# **Attachment A**

Correspondence and Plans for the Rooftop Plant Area and Parapet Zone of Building C and Tree 40

Cc: Christopher Corradi; Angela Guo; Sky Zheng
Subject: Wattle Street - Courtyard Building Plant Room
Date: Wednesday, 27 March 2024 2:11:01 PM
Attachments: M-2013 HVAC - BUILDING C- ROOF[].pdf

MECHANICAL SERVICES
HVAC - BUILDING C-ROOF

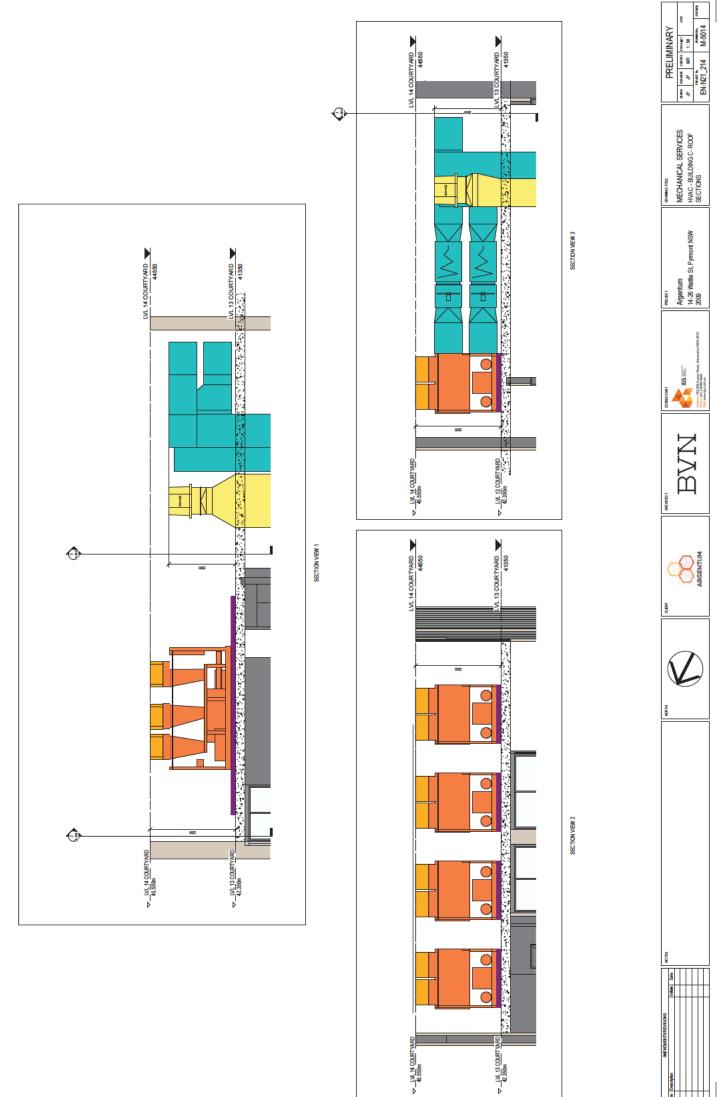
- The roof of the courtyard building is proposed to accommodate the air-cooled chillers that will service the entire development.
- The chillers require unobstructed access to the sky and cannot be located in a basement. Pumps and other mechanical plant that do not require air and sky access have been located in the basement.

- The height of the rooftop plant enclosure (parapet) corresponds with the height of the chillers as illustrated in the additional plans and details.
- Any lowering of the parapet will expose the chillers to view and disrupt the building architecture.
